## NEBRASKA CAPITOL ENVIRONS COMMISSION

### AGENDA

## **Item 2: Residential street rehab project near McPhee School**

# CITY OF LINCOLN, NE (2021) PAVING REHABILITATION OF THE McPHEE SCHOOL NEIGHBORHOOD PAVING C.I.P. #705270

TYPICAL SECTIONS

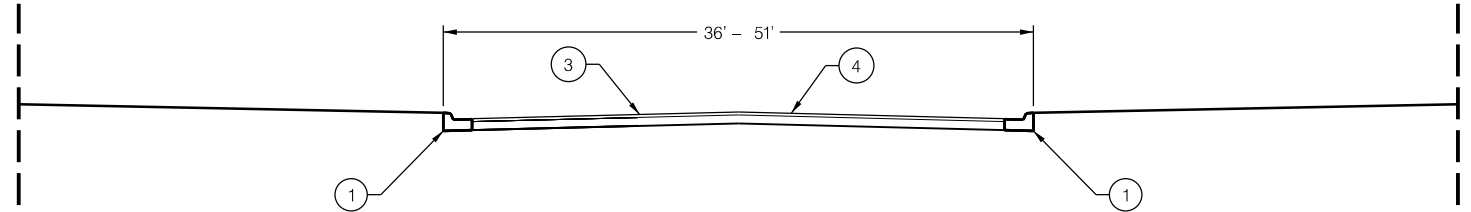
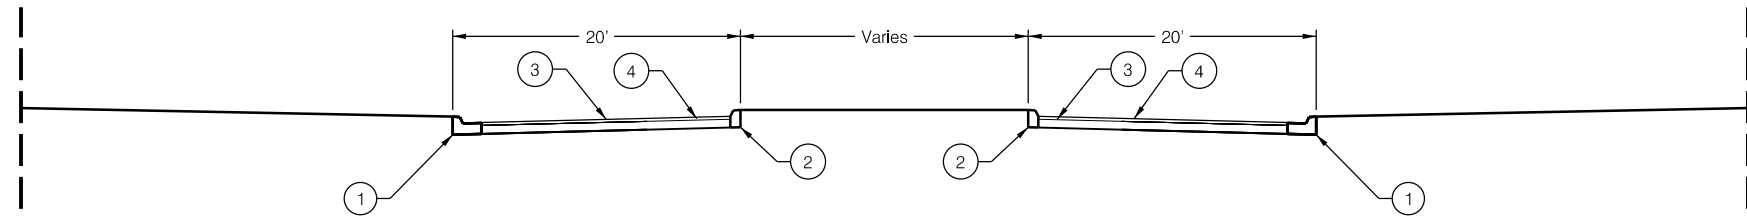
Another improvement being proposed along Lincoln Mall is the addition of a 6' wide bike lane on each side of the street, providing on-street bicycle access from S 10<sup>th</sup> to S 14<sup>th</sup> Street. The proposed bike lanes will be unprotected and run directly parallel to 12' drive lanes.

The S 14<sup>th</sup> Street block from Lincoln Mall to K Street is also being proposed to undergo an on-street lane reconfiguration. In this case, this existing one-way block would be converted to accommodate two-way traffic. In addition to new lane markings, the angled parking along the west side of S 14<sup>th</sup> Street will need to be flipped to address the change of traffic direction, and the northbound stop sign on S 14<sup>th</sup> Street will be eliminated.

The existing decorative pavement treatments at the corners of the Lincoln Mall intersections play a role in the establishment of the rhythm and organization that Design Standard 18 references. Ideally, improvements at these nodes should not disrupt that rhythm and organization. While the original proposal submitted by LTU did appear to deviate from this standard, the revised proposal aims only to preserve or restore the decorative pavement treatments that are already in place.

Guideline 18.5 references key characteristics of allowed pavement material. It appears that the proposal put forth by LTU meets this guideline.

*Recommended Finding: The proposed residential rehab project generally conforms with the Capitol Environs Design Standards.*
